5TH STREET CONDITIONAL USE PERMIT

PRELIMINARY SITE PLAN

JACKSON CASTANEDA & SAMANTHA KEIMIG
5TH ST CONDITIONAL USE PERMIT
PRELIMINARY SITE PLAN
CITY OF PUYALLUP
WASHINGTON

JOB NO.: 2218-001-021
DWG. NAME: EN-02
DESIGNED BY: BML
DRAWN BY: DCL
CHECKED BY:
DATE: 10/24/2022
DATE OF PRINT:
EN-02
1 OF 1 SHEETS

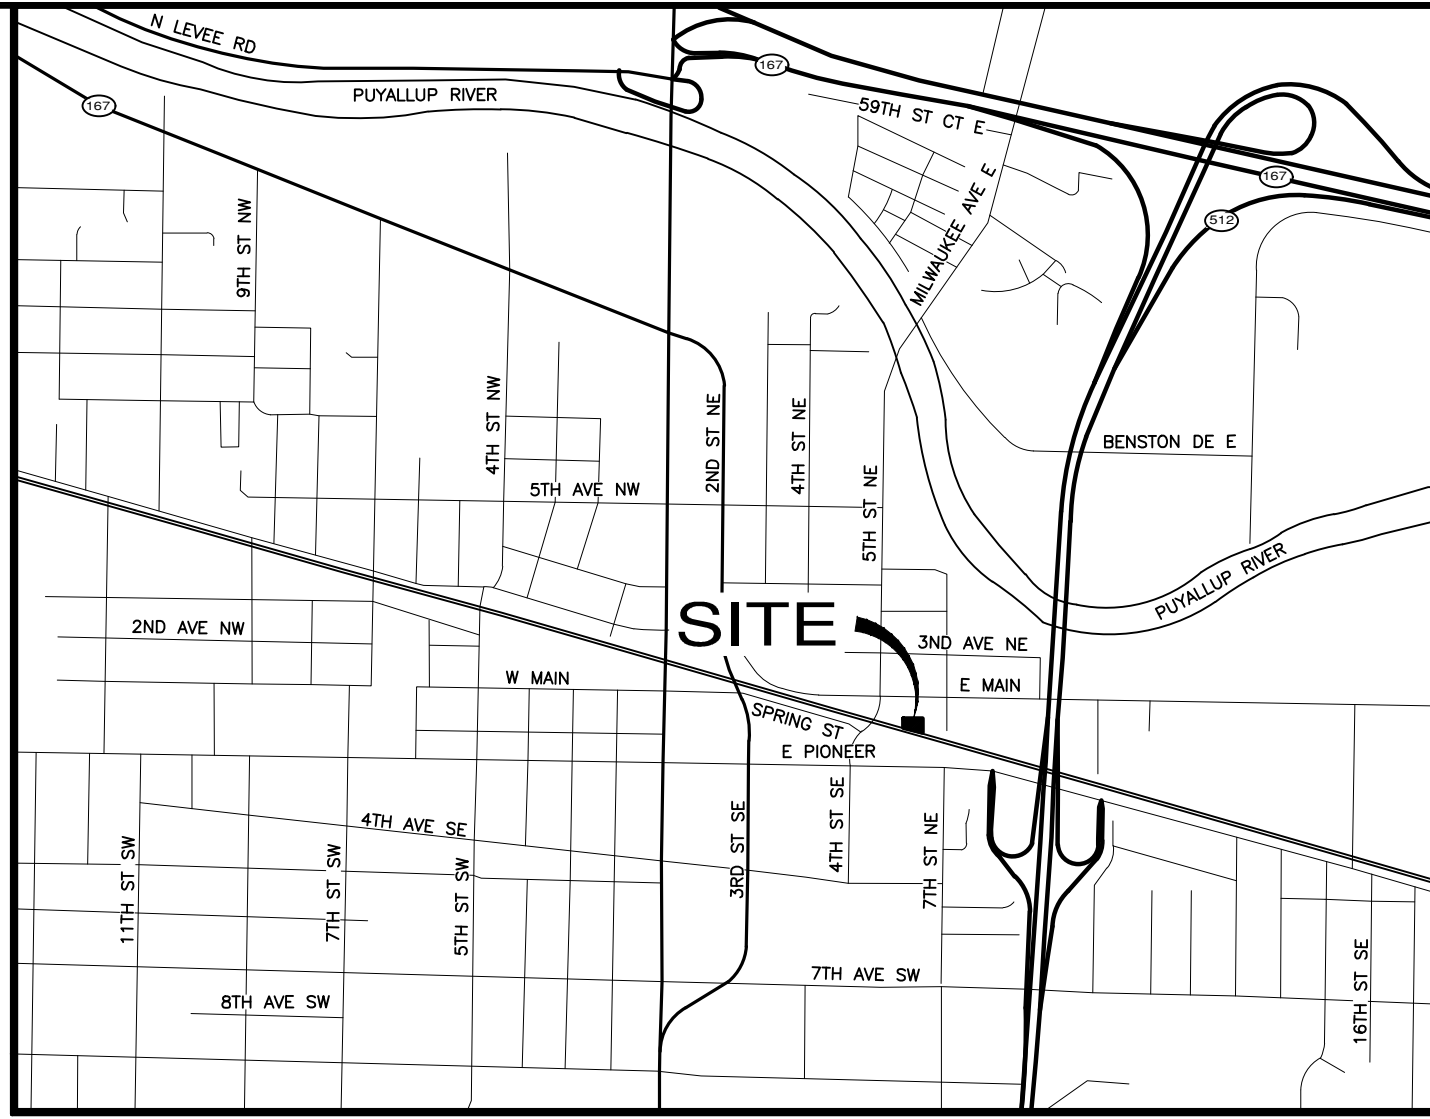
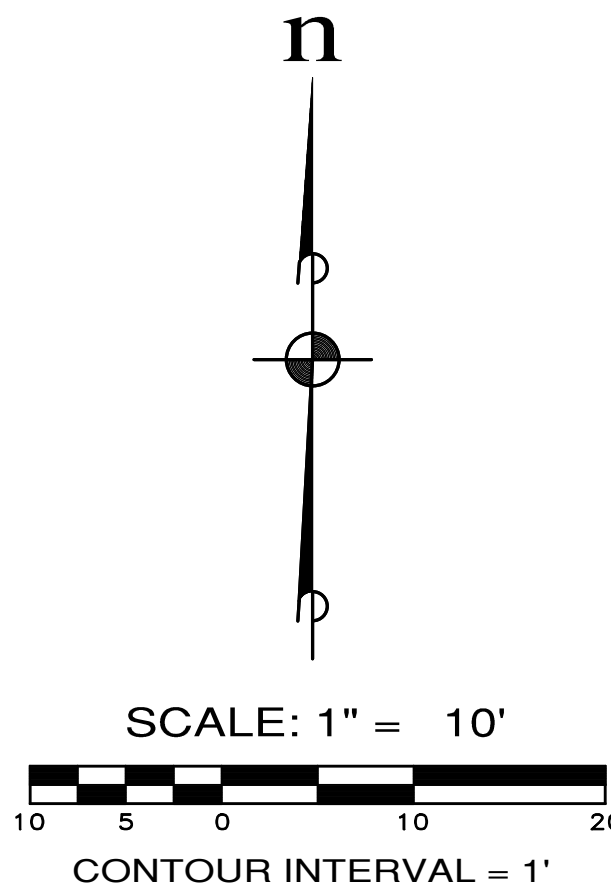
Please include calculation of parking ratio requirements. Include the amount of floor area being designated for office space, warehouse/storage space in as well. [site plan, EN-02]

separate onsite and offsite new/replaced impervious surfaces

In the conditional use permit application, it is stated that the intent for the pedestrian plaza space is to have a "wooner" feel and characteristics. It is stated that city-standard landscape buffer for the parking will be required and that a plaza will be provided along the building frontage and is proposed to double as access to roll-up garage entries to each unit. Decorative hard surfacing is proposed to be in the area along with streetscape features such as planters and small seating areas located in non-travel areas between the units. The city is still generally receptive to this "wooner"-type proposal. However, additional detailed plans for this "wooner" concept are required in your re-submittal to better understand the concept, conduct review, and make the CUP findings. Staff will need to discuss the process and criteria for this requested deviation from the design standards. Please provide scaled elevations and plans that reflect this design intent.

[site plan, EN-02]

Per (PMC 20.30.037 (2)(a)) and (PMC 20.26.300 (3)(b)(i)), the pedestrian plaza is required to include amenities such as bike parking, bench seating, planters, fountains, artwork, decorative railing, decorative light fixtures, hanging baskets or other features that are pedestrian scaled in nature. [site plan, EN-02]

Proposed sewer and water main locations within roadway do not meet COP Design standards. See City Standard Details

See COP Design Standards Section 208 for trash enclosure requirements.

Per COP Design Standards, "For stormwater pipe crossing over sanitary sewers, a minimum of 12-inches of vertical clearance shall be provided between the systems. If the stormwater pipe is crossing below the sanitary sewer, a minimum of 18-inches of vertical separation shall be provided."

Utilities may only leave the site perpendicular to ROW and with a cleanout at the property line. [Site Plan, Pg1]

Provide Sewer cleanout at property line. [Site Plan, Pg1]

Show water connection in 7th St SE on plans. [Site Plan, Pg1]

Show Sewer connection in E Main Ave on plans. [Site Plan, Pg1]

Where (if any) are trash and recycling receptacles being placed? Provide the height of the proposed trash and recycling receptacle and associated enclosures on the elevation plans. Per PMC 20.30.045 (7), trash and recycling receptacles shall be screened from adjacent properties and public rights-of-way by an opaque visual barrier no lower than the highest point of the receptacles. [site plan, EN-02]
